PRE-HEARING
GROUND-WATER DISCHARGE PLAN ANALYSIS
for
HOMESTAKE'S URANIUM MILL NEAR
MILAN, NEW MEXICO
HOMESTAKE MINING COMPANY

GROUND WATER SECTION
GROUND WATER QUALITY AND HAZARDOUS WASTE BUREAU
NEW MEXICO ENVIRONMENTAL IMPROVEMENT DIVISION

January 1984

FIGURE 11. PREDICTED WATER-LEVEL ELEVATIONS, AFTER 110 DAYS OF MURRAY ACRES INJECTION

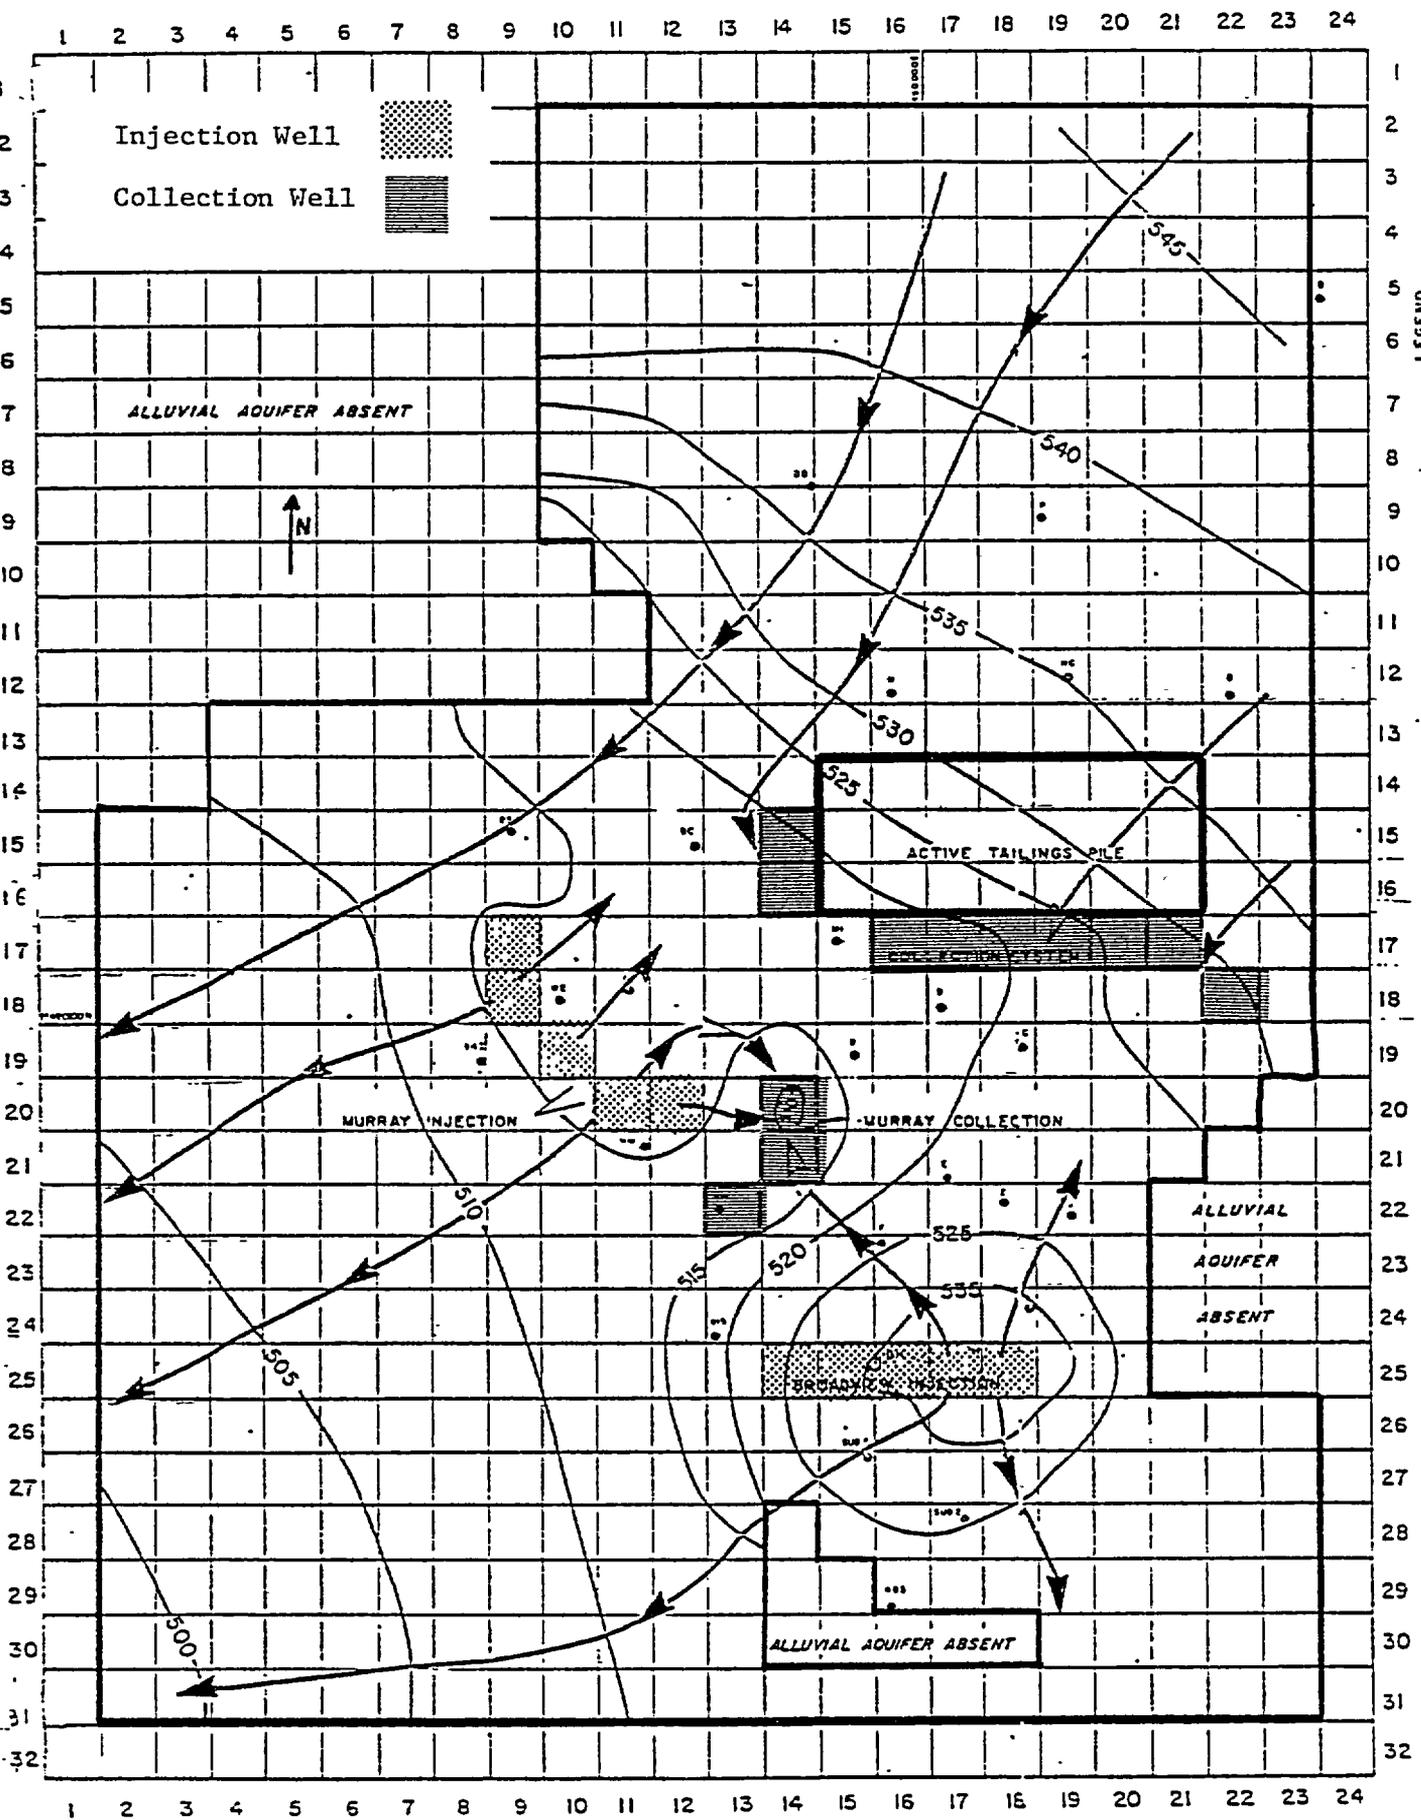
Figure 11 shows predicted water-level elevations at 110 days after beginning operation of the Murray Acres injection system (Nov. 1982). Injection of water at a rate of 300 gpm quickly reverses the ground-water flow direction northeast of the Murray Acres injection line to a distance mid-way to the tailings collection wells. Actual reversal of the ground-water gradient is expected to be significantly quicker than suggested by the simulation, because the water-level elevation calibration lagged the observed water-level increases in Broadview Acres. Figure 11 also shows that the San Mateo alluvial ground-water flow down-gradient of the active-tailings reservoir is completely reversed except for the flow lines which converge on

FIGURE 21. PREDICTED SELENIUM CONCENTRATIONS 1000 FEET DOWNGRADIENT OF FELICE ACRES

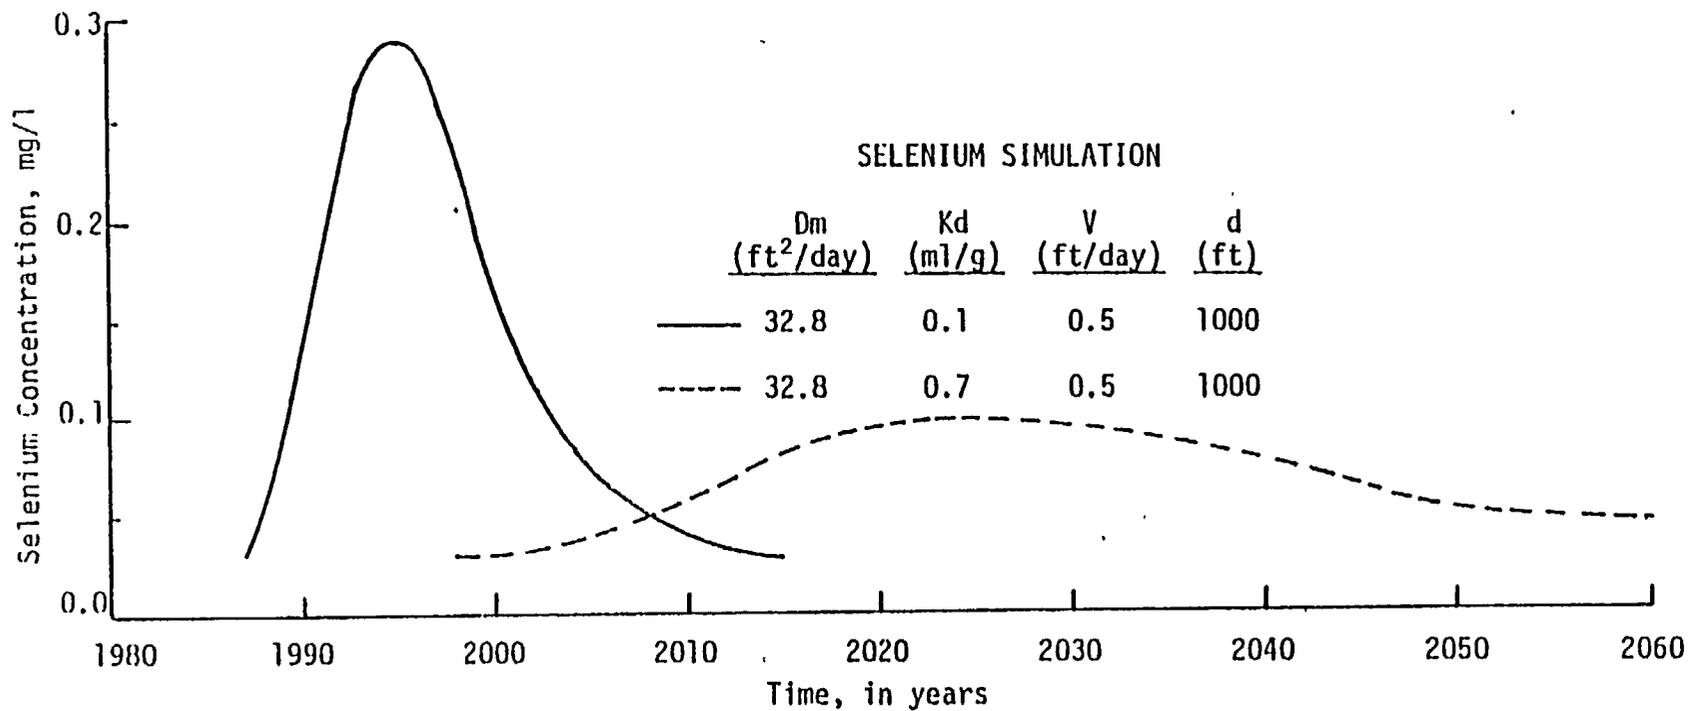
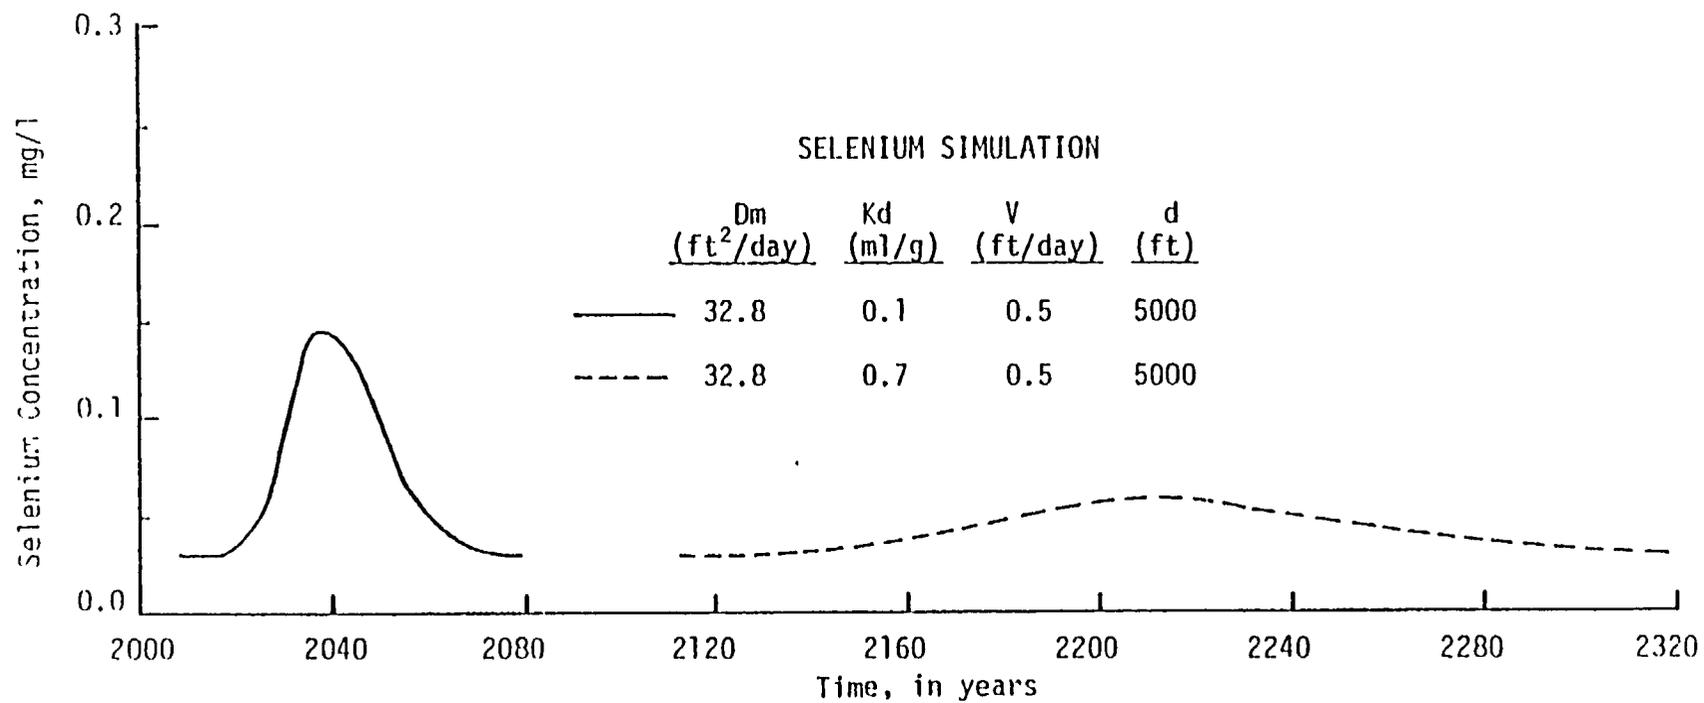
The U.S.G.S. solute transport numerical model was also used by the EID to determine the accuracy of parameters used in the Homestake model. Simulation involved the use of the same grid spacing and aquifer parameters. However, discharge was added for the inactive-tailings reservoir and the water table was calibrated using a constant head rather than constant flux boundary. Results of the EID simulation indicate that

the observed sulfate distribution cannot be calibrated if the active-tailings reservoir seepage is 150 gpm and the inactive-tailings reservoir is assumed to discharge at 75 gpm. The reason for this is that high concentrations move farther down-gradient than actually observed. Therefore, Homestake's use of 75 gpm, discharging from the active-tailings reservoir and no discharge from the inactive-tailings reservoir, appears to be valid. However, the EID calibration was not able to match the extent of sulfate attenuation down-gradient in Broadview, Murray and Felice acres with the dispersivities and concentrations in the discharge used by Homestake in their ground-water model. This implies that the two-dimensional model may be influenced by movement in the 3rd or vertical-dimension. The fact that tailings seepage has reached ground water in the upper Chinle substantiates that this is occurring.

Because Homestake accounted for this discrepancy by changing discharge rates and concentrations until the model was calibrated, the flow system and concentration distribution projections are probably correct. However, the modeled seepage rates and concentrations are probably lower than actual rates and concentrations because of flow in the 3rd-dimension which was not accounted for in the Homestake model.
